Access Audit Site Report

Hueco Tanks State Park and Historic Site

Accessibility Evaluation

Inspection Date: 10/19/2022

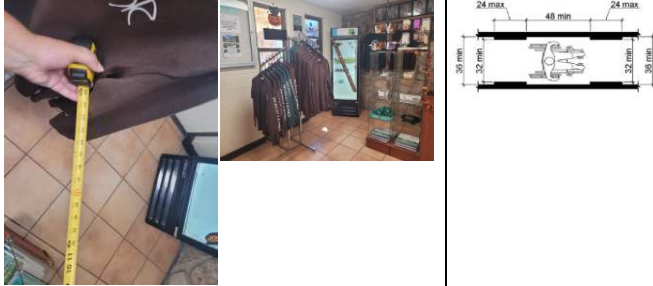
7	Headquarters Area: HQ - Exterior Accessible Route	[31.9263187, -106.0423799]	The curb ramp slope exceeds the maximum running slope (Parallel to the direction of travel) allowable of 8.33%. Curb ramps should have the least possible slope but in no case more than 8.3% (1:12).	11.7% slope at curb ramp	Replace curb ramp with a compliant curb cut that doesn't project into the access aisle.	2015 ABAAS Section: 406.1 2012 TAS Section: 406.1 2010 ADAS Section: 406.1

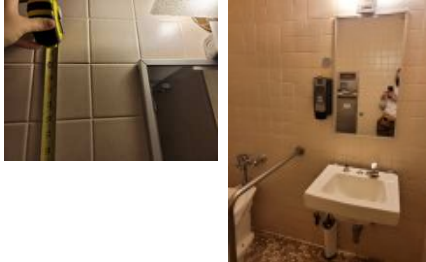
27	Headquarters Area: HQ - Men's Restroom	[31.926432, -106.0424483]	The operable part is not accessible because there is not adequate clear floor space for either a forward or side approach. The clear floor or ground space shall be 30 inches minimum by 48 inches minimum.	Grab bar and sink with no knee clearance in CFS of soap dispenser	Remove, or relocate free standing grab bar in CFS at fixtures and operable parts along the AR.	2015 ABAAS Section: 305.3 2012 TAS Section: 305.3 2010 ADAS Section: 305.3

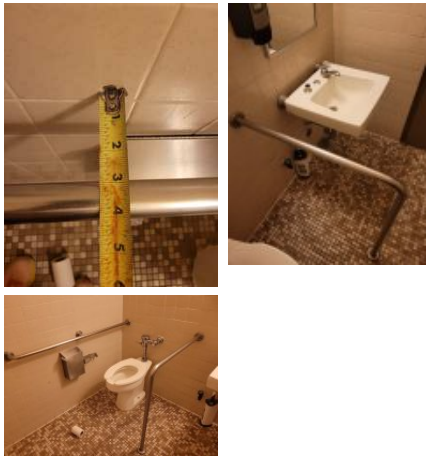
33	Headquarters Area: HQ - Men's Restroom	[31.926416, -106.0424322]	The toilet paper dispenser does not allow a continuous flow. Toilet paper dispensers shall be 7 inches minimum and 9 inches maximum in front of the water closet measured to the centerline of the dispenser. The outlet of the dispenser shall be 15 inches minimum and 48 inches maximum above the finish floor and shall not be located behind grab bars. Dispensers shall not be of a type that controls delivery or that does not allow continuous paper flow. There shall be a clearance of 1 1/2 inches minimum below the grab bar.	Flat bar does not allow roll to spin for continuous delivery of TP	Replace toilet paper dispenser with one that provides continuous flow of paper.	2015 ABAAS Section: 604.7 2012 TAS Section: 604.7 2010 ADAS Section: 604.7

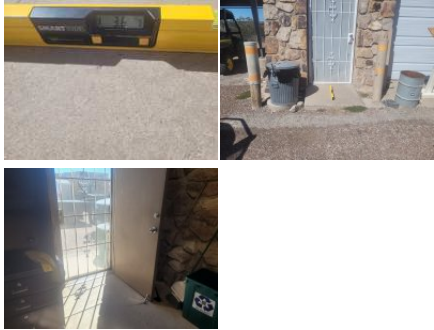
Finding Number	Area Description	Lat/Long	Finding	As Built	Recommendation	Citation	Photos	Figure
39	Headquarters Area: HQ - Women's Restroom	[31.9264527, -106.0424215]	The side grab bars are not in the correct location. Grab bars on the side wall must be installed so that the end closest to the rear wall is maximum 12" from the rear wall. The end furthest from the rear wall must be mounted minimum 54" from the rear wall.	Non-compliant grab bars present; side grab bar extends 51" from rear wall	Replace side grab bar with a 42" long bar mounted to max 12" from the rear wall at the close end and min 54" on the far end, and 33" to 36" AFF.	2015 ABAAS Section: 604.5.1 2012 TAS Section: 604.5.1 2010 ADAS Section: 604.5.1		
40	Headquarters Area: HQ - Women's Restroom	[31.9264299, -106.0424295]	The rear grab bar is not 36" long or is not mounted in the correct location. The rear grab bar must be a minimum of 36" long and extend from the toilet centerline a minimum 12" towards the wall side and a minimum 24" towards the open side of the toilet. Grab bars shall be installed in a horizontal position, 33 inches minimum and 36 inches maximum above the finish floor measured to the top of the gripping surface and the space between the grab bar and the top of the tank shall be 1-1/2 inches minimum.	Lacks rear grab bar	Replace free standing grab bar with a rear grab bar that is 36" long, mounted behind the toilet, 12" to the wall side of center and 24" to the open side and 33" to 36" AFF.	2015 ABAAS Section: 604.5.2 2012 TAS Section: 604.5.2 2010 ADAS Section: 604.5.2

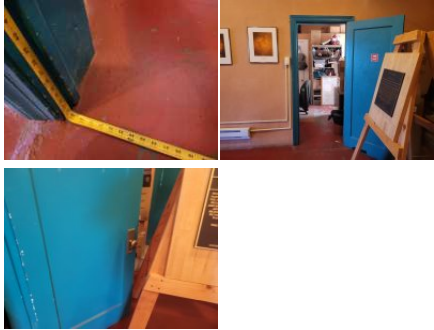
76	Interpretive Center: Interpretive - Public Spaces	[31.9248133 , -106.0416847]	The operable part is positioned too high for either a side or front approach. Where a clear floor or ground space allows a parallel approach to an element and the side reach is unobstructed, the high side reach shall be 48 inches maximum and the low side reach shall be 15 inches minimum above the finish floor or ground. Where a forward reach is unobstructed, the high forward reach shall be 48 inches maximum and the low forward reach shall be 15 inches minimum above the finish floor or ground.	Museum Space - Coat hooks at 60"	Remount operable parts to be in reach range of 15" min to 48" max.	2015 ABAAS Section: 308.1 2012 TAS Section: 308.1 2010 ADAS Section: 308.1

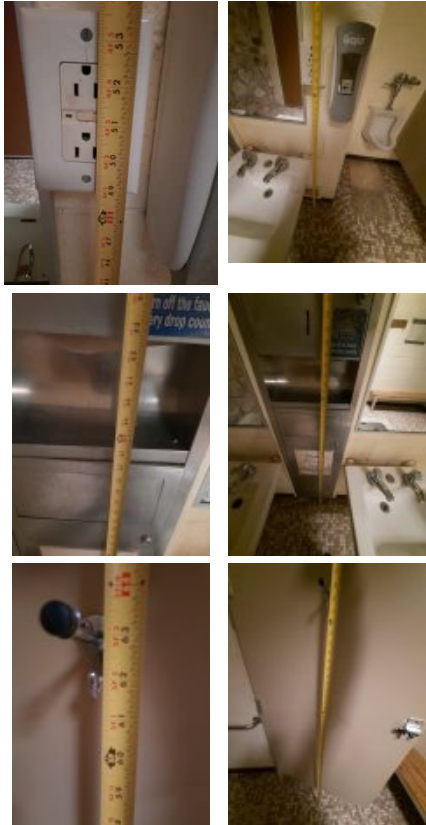
99	Campground: Campground - Exterior Accessible Route	[31.9195833, -106.0363464]	There is no accessible route to the restroom building. At least one accessible route shall connect accessible buildings, accessible facilities, accessible elements, and accessible spaces that are on the same site.	Lacks accessible route to restroom building due to surface	Create an accessible route with crushed stone or other outdoor material from parking or walkway to the restroom building.	2015 ABAAS Section: F206.2.2 2012 TAS Section: 206.2.2 2010 ADAS Section: 206.2.2

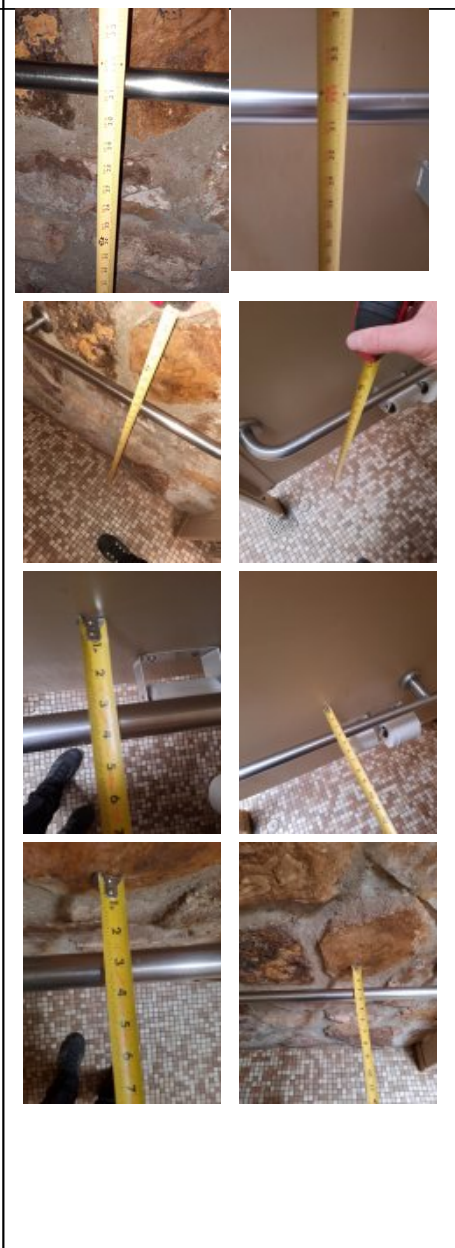
Finding Number	Area Description	Lat/Long	Finding	As Built	Recommendation	Citation	Photos	Figure
152	Restrooms at Gate: Gate - Men's Restroom	[31.9265999, -106.0452571]	The mirror is mounted too high. Mirrors must have the bottom edge of the reflecting surface a maximum of 40 inches above the floor if above a sink or counter. Mirrors not located above lavatories or countertops shall be installed with the bottom edge of the reflecting surface 35 inches maximum above the finish floor or ground.	Bottom edge of mirror at 49.5"	Replace mirror mount to max 40" AFF to the bottom reflective surface and 74" to the top.	2015 ABAAS Section: 603.3 2012 TAS Section: 603.3 2010 ADAS Section: 603.3		
153	Restrooms at Gate: Gate - Men's Restroom	[31.926609, -106.0452732]	Knee clearance at 27 inches off the floor is not 8 inches minimum deep. The knee clearance, measured from the bottom of the apron or the outside bottom edge of the lavatory, must be 27 inches at a point located 8 inches back from the front edge and continuing to 11 inches minimum in depth at 9 inches above the floor. The top of the lavatory rim may be no higher than 34 inches.	Sink lacks knee clearance	Replace sink with one providing 27" knee clearance that is a min 8" deep.	2015 ABAAS Section: 306.3.1, 306.3.2, 306.3.3, 306.3.4, 306.3.5 2012 TAS Section: 306.3.2, 306.3.3, 306.3.4, 306.3.5, 306.3.1 2010 ADAS Section: 306.3.3, 306.3.2, 306.3.4, 306.3.5, 306.3.1

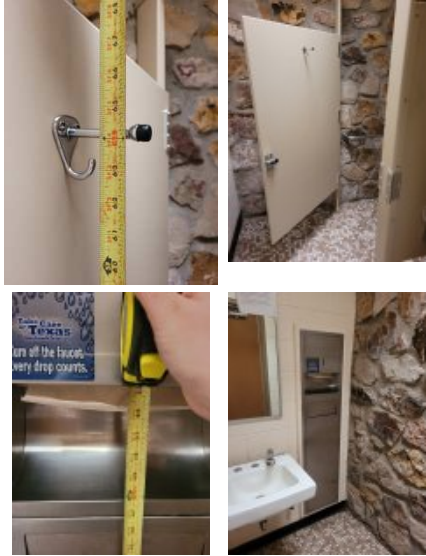
Finding Number	Area Description	Lat/Long	Finding	As Built	Recommendation	Citation	Photos	Figure
			minimum 12" above the grab bar to any dispenser or other obstruction.			609.4, 609.3 2010 ADAS Section: 609.3, 609.4

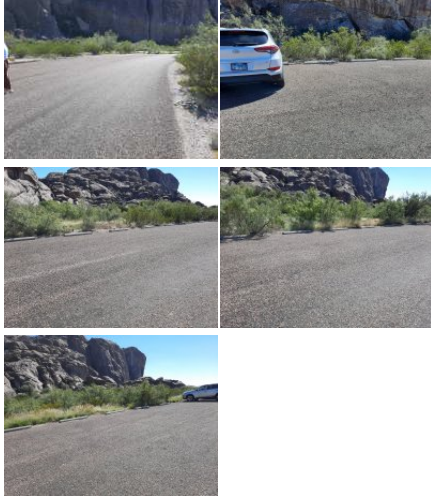
214	Pond Trail Restrooms: Clivus/Backcountry Toilet	[31.920138, -106.0419611]	The restroom sign does not comply with one or more applicable requirements for the location, height, and properties of the sign.	Sign lacks visual contrast	Replace sign with one of contrasting colors that includes Braille, raised characters, and the symbol of accessibility and mount on the wall, latch side of the door, 48" to the baseline of the lowest character and 60" to the baseline of the highest character.	2015 ABAAS Section: F216.2, 703.1, 703.2, 703.5, 703.6 2012 TAS Section: 216.2, 703.1, 703.2, 703.5, 703.6 2010 ADAS Section: 216.2, 703.1, 703.2, 703.5, 703.6		
215	Pond Trail Restrooms: Clivus/Backcountry Toilet	[31.9201391, -106.0419665]	The toilet is not located within the range allowed from the side wall or partition. The centerline of the toilet must be 16 to 18 inches from the side wall.	Centerline of toilet is 24" from wall	Remount toilets to 16" to 18" from the side wall to centerline.	2015 ABAAS Section: 604.2 2012 TAS Section: 604.2 2010 ADAS Section: 604.2
